PLANNING NMA-CHANGE LIST		
ID	Proposed Changes to plans that are 'Non Material'	Reason for 'Amendment'
A	Changes to Common stair towards compliance for general access where a clear landing needs to be provided and to accommodate smoke control. Circulation area and internal doorway to stairs rearranged to adapt corridor aisle. Stairs, structurally stacked for construction leading towards the corridor or lobby next to the stair being provided with a smoke vent and a store area provision on ground level. Rearrangement in plan due to the above visible on the Northeast facade. Window openings, adapted to suit mentioned changes/rearrangement.	Compliance towards Building Regulations, Part-K-Protection from falling, collision and impact and Part-B-Fire safety
B	Changes to Communal lifts and stairs towards compliance for firefighting where a firefighting shaft is required as the building is over 18m and to accommodate smoke control and building services. Circulation area internal doorway to stairs and clear landing for lifts rearranged to adapt corridor aisle. Stairs, structurally stacked for construction leading towards a vertical smoke shaft that opens at roof level with rationalised comm

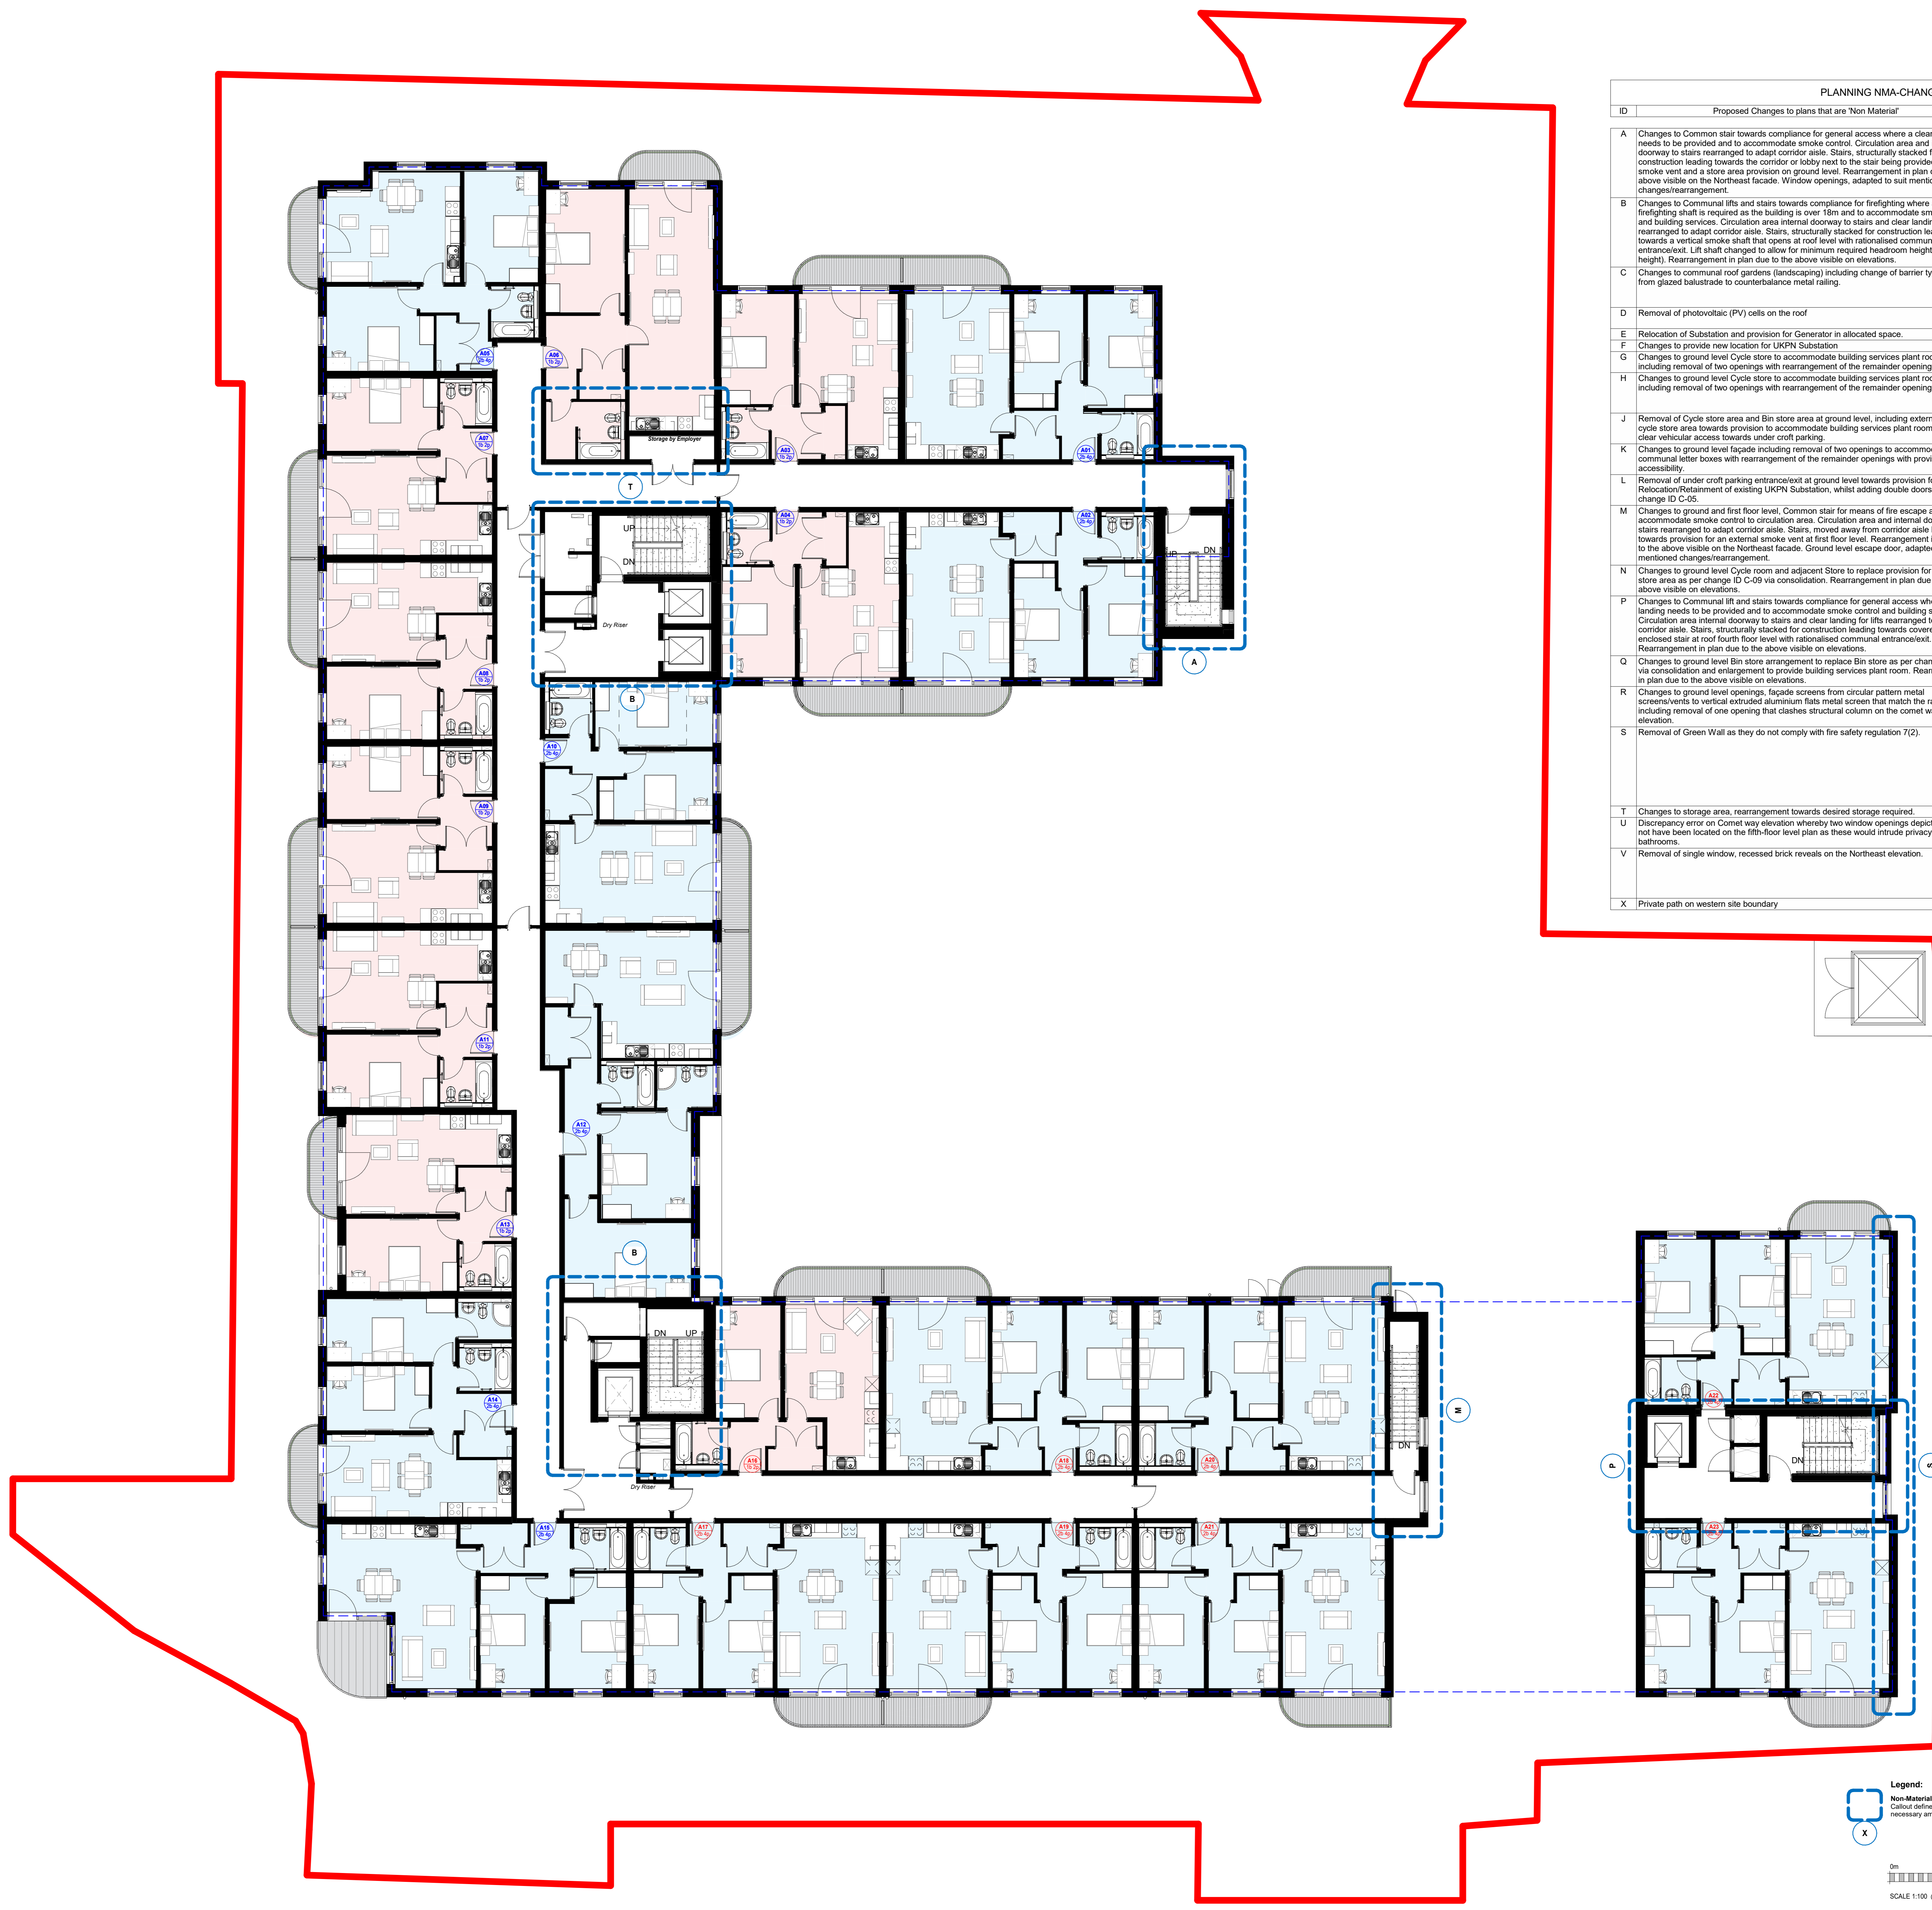
C	Changes to communal roof gardens (landscaping) including change of barrier type (railing) from glazed balustrade to counterbalance metal railing.	To contribute positively towards biodiversity via balance of soft and hard landscaping schemes including provisions for bird and bat boxes, whilst maintaining overall uniformity for railing type.
D	Removal of photovoltaic (PV) cells on the roof	PV was not required as Part L requirement was met using Exhaust Air Heat Pumps.
E	Relocation of Substation and provision for Generator in allocated space.	Provision for separate secluded area for generator
F	Changes to provide new location for UKPN Substation	Provision for future relocation for UKPN Substation
G	Changes to ground level Cycle store to accommodate building services plant rooms including removal of two openings with rearrangement of the remainder openings.	Provision towards Building Services, Secondary LV switch room and Comms room.

H	Changes to ground level Cycle store to accommodate building services plant rooms including removal of two openings with rearrangement of the remainder openings.	Provision towards secure access and splitting into 4 small bin stores to comply with recent updates of having maximum 8 large (1100lrs) receptacles within.
J	Removal of Cycle store area and Bin store area at ground level, including external door in cycle store area towards provision to accommodate building services plant room including clear vehicular access towards undercroft parking.	Provision towards Building Services, Primary LV switch room and vehicular access towards undercroft parking.
K	Changes to ground level facade including removal of two openings to accommodate communal letter boxes with rearrangement of the remainder openings with provision for accessibility.	Provision towards communal letter boxes
L	Removal of undercroft parking entrance/exit at ground level towards provision for Relocation/Retention of existing UKPN Substation, whilst adding double doors as per change ID-C-05.	Provision towards single point of entry/exit for undercroft parking and towards relocation/retention of existing UKPN Substation mentioned in change ID-E.

M	Changes to ground and first floor level, Common stair for means of fire escape and to accommodate smoke control to circulation area. Circulation area and internal doorway to stairs rearranged to adapt corridor aisle. Stairs, moved away from corridor aisle leading towards provision for an external smoke vent at first floor level. Rearrangement in plan due to the above visible on the Northeast facade. Ground level escape door, adapted to suit mentioned changes/rearrangement.	Compliance towards Building Regulations, Part-B-Fire safety.
N	Changes to ground level Cycle room and adjacent Store to replace provision for Cycle store area as per change ID C-09 via consolidation. Rearrangement in plan due to the above visible on elevations.	Provision towards replacement of removed cycle store mentioned in change ID-J.
P	Changes to Communal lift and stairs towards compliance for general access where a clear landing needs to be provided and to accommodate smoke control and building services. Circulation area internal doorway to stairs and clear landing for lifts rearranged to adapt corridor aisle. Stairs, structurally stacked for construction leading towards covered and enclosed stair at roof fourth floor level with rationalised communal entrance/exit. Rearrangement in plan due to the above visible on elevations.	Compliance towards Building Regulations, Part-K-Protection from falling, collision and impact, Part-B-Fire safety and Provision for stair enclosed/walkway that is directly covered.

Q	Changes to ground level Bin store arrangement to replace Bin store as per change ID C-09 via consolidation and enlargement to provide building services plant room. Rearrangement in plan due to the above visible on elevations.	Provision towards replacement of removed Bin store mentioned in change ID-J and provision for BCW Tank room
R	Changes to ground level openings, facade screens from circular pattern metal screens/vents to vertical extruded aluminium flats metal screen that match the railing type, including removal of one opening that clashes structural column on the corner way elevation.	To maintaining overall architectural uniformity and structural framing.
S	Removal of Green Wall as they do not comply with fire safety regulation 7(2).	Regulation 7(2), requires all residential blocks with top-storey heights over 18m to have all materials which become part of an external wall or specified attachment (e.g., balconies) to achieve class A2-s1, d0 or class A1, except for materials which are exempt as per regulation 7(3). Additionally, membranes used as part of external wall construction above ground should achieve a minimum of class B-s3, d0.

T	Changes to storage area, rearrangement towards desired storage required.	Provision towards desired storage required.
U	Discrepancy error on Comet way elevation whereby two window openings depicted would not have been located on the fifth-floor level plan as these would intrude privacy for the bathrooms.	Discrepancy error
V	Removal of single window, recessed brick reveals on the Northeast elevation.	The recessed brick reveals is towards the left of a single pane window for levels 1-4, whilst it changes to a double pane for level 5. To maintain architectural uniformity, we have detailed a constant double pane window for all levels.
X	Private path on western site boundary	For Façade maintenance MEWP access.
